MIL-PRF-19500/746C
w/AMENDMENT 2
19 April 2018
SUPERSEDING
MIL-PRF-19500/746C
w/AMENDMENT 1
30 May 2017

PERFORMANCE SPECIFICATION SHEET

TRANSISTOR, FIELD EFFECT RADIATION HARDENED, N-CHANNEL, SILICON, SURFACE MOUNT, TYPES 2N7587, 2N7589, 2N7591, AND 2N7593, QUALITY LEVELS JANTXV, JANS, JANHC, AND JANKC

FIGURE 1. Dimensions and configuration (TO-276AA, SMD-0.5), with metal lid or ceramic lid.

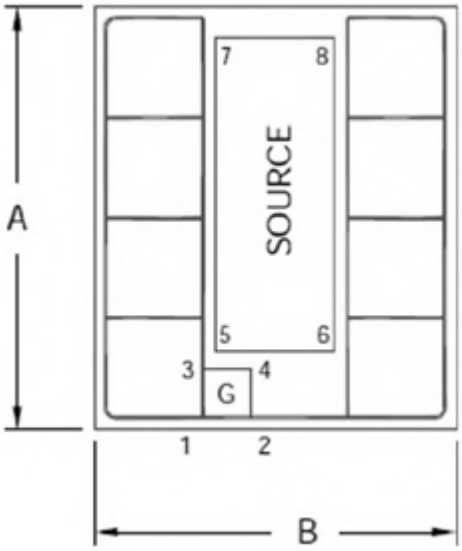
U3	Indicates a metal lidded 3 pad surface mount package similar to a TO-276AA (SMD-0.5) (see figure 1).
U3C	Indicates a ceramic lidded 3 pad surface mount package similar to a TO-276AA (SMD-0.5) (see figure 1).
	Indicates a JANHC or JANKC die, see figure 2.

* 3.4 Interface requirements and physical dimensions. The interface requirements and physical dimensions shall be as specified in MIL-PRF-19500 and herein. The device package style is either a metal lidded or ceramic lidded TO-276AA in accordance with figure 1 for all encapsulated devices. See figure 2 for unencapsulated JANHC/JANKC die.

* FIGURE 2. JANHC and JANKC (A-version) die dimensions.

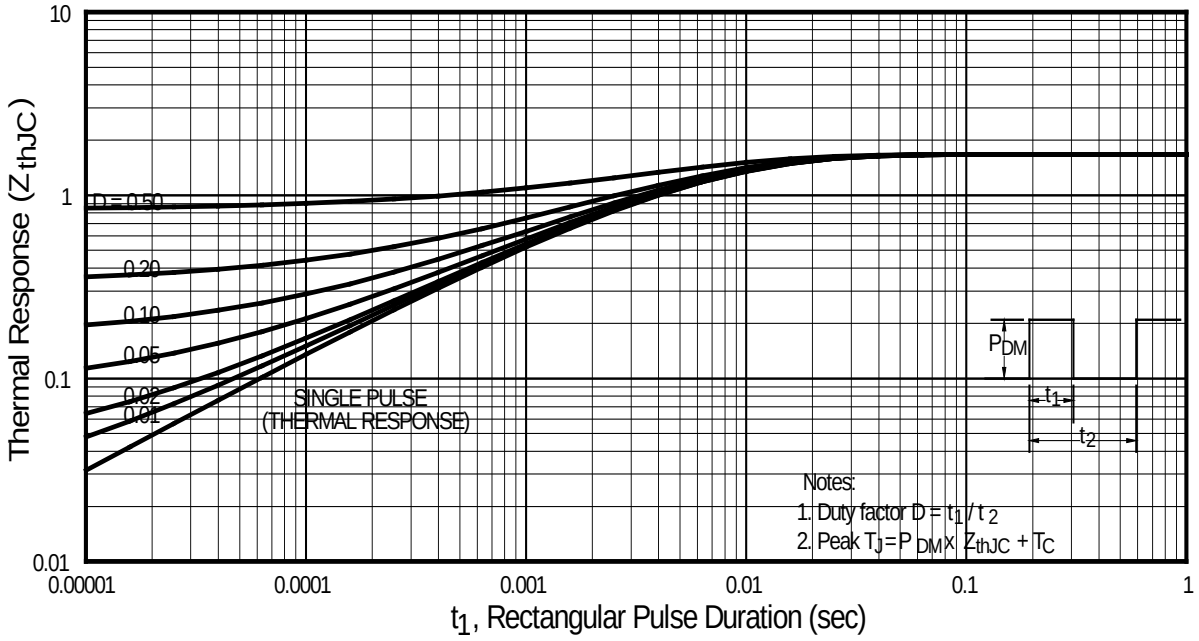
1.5.6 Die identifiers for unencapsulated devices (manufacturers and critical interface identifiers). The manufacturer die identifier that is applicable for this specification sheet is "A" (see figure 2 and 6.5).

* FIGURE 4. Maximum drain current versus case temperature graphs.

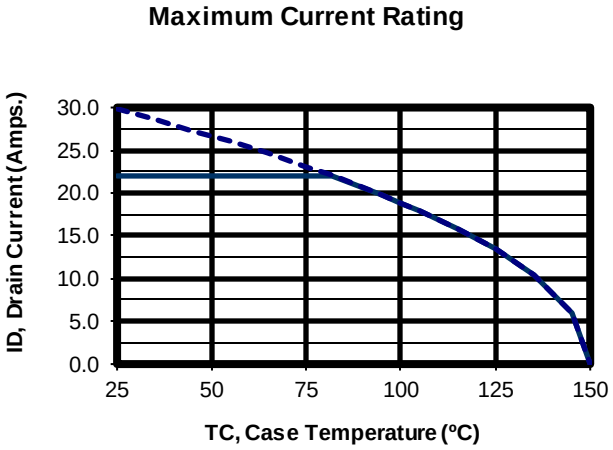
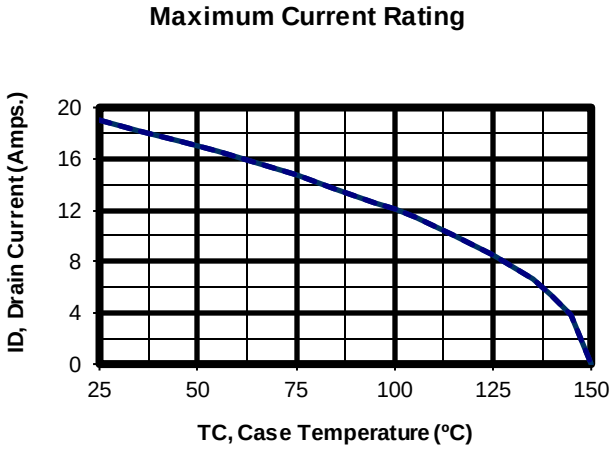
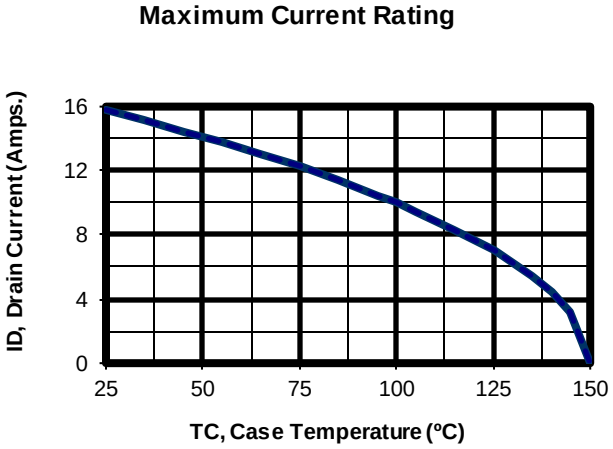
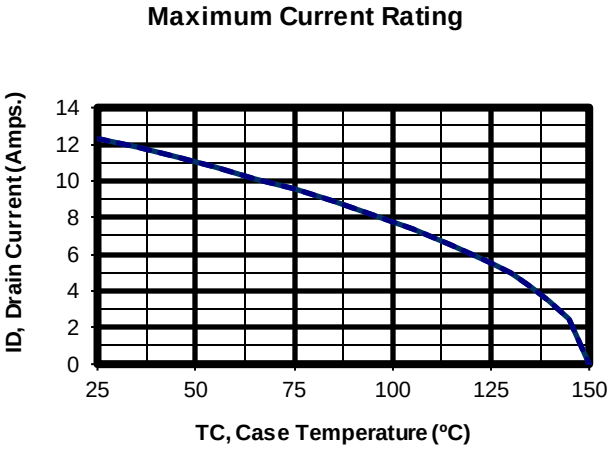
(5) See figure 4, maximum drain current graph.
(6) I_{DM} = 4 X I_{D1}; I_{D1} as calculated by footnote (3).

* FIGURE 5. Safe operating area graph.

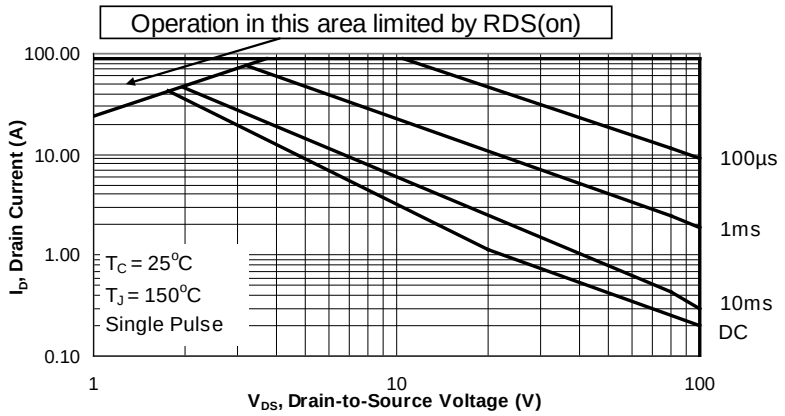
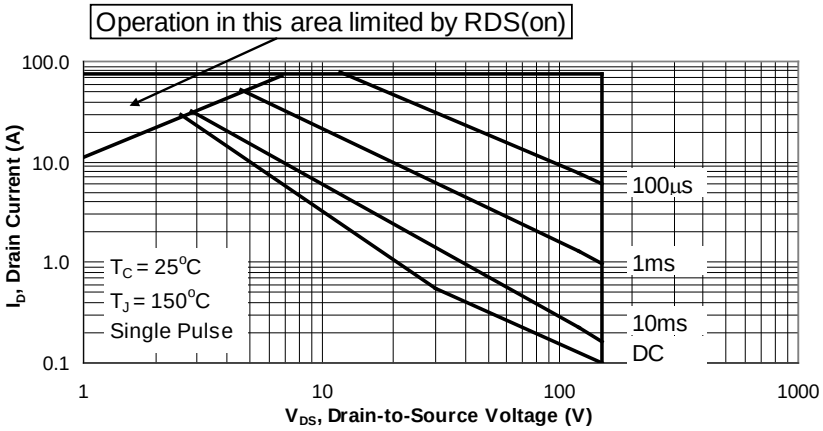
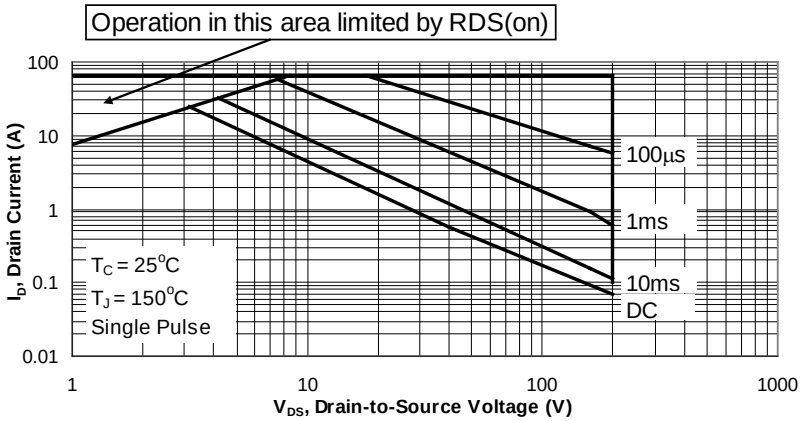
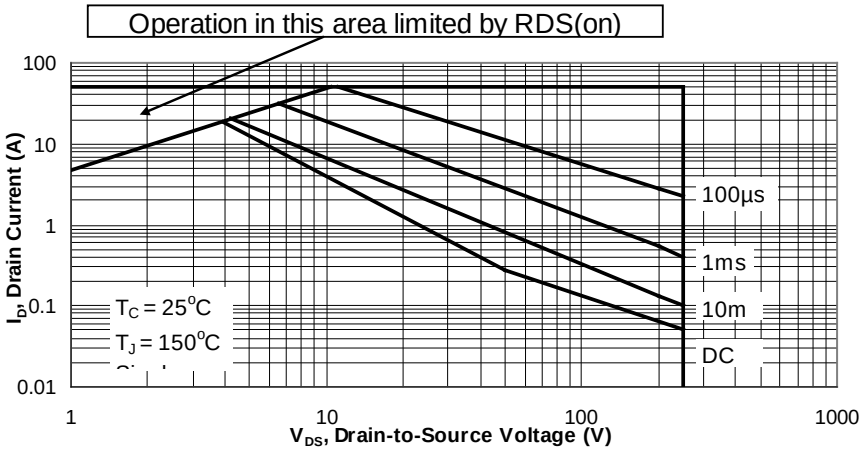
Inspection 1/, 2/	MIL-STD-750		Symbol	Limits		Unit
	Method	Condition		Min	Max	
Subgroup 5						
Safe operating area test	3474	See figure 5 4; tp = 10 ms min. VDS = 80 percent of max. rated VDS				
Electrical measurements		See table I, subgroup 2				
Subgroup 6						
Not applicable						
Subgroup 7						
Gate charge	3471	Condition B, $I_D = I_{D1}$, V_{GS} = 12 V dc V_{DD} = 50 percent of rated V_{DS}				
On-state gate charge and turn-off gate charge			$Q_{G(ON)}$ $Q_{G(OFF)}$		50 50	nC
Gate to source charge (turn-on and turn-off)			Q_{GS1} Q_{GS2}		15 15	nC
Gate to drain charge (turn-on and turn-off)			Q_{GD1} Q_{GD2}		20 20	nC
* Reverse recovery time	3473	Condition A, di/dt = -100 A/µs, $V_{DD} \leq$ 50 V, $I_D = I_{D1}$	t_{rr}		350	ns
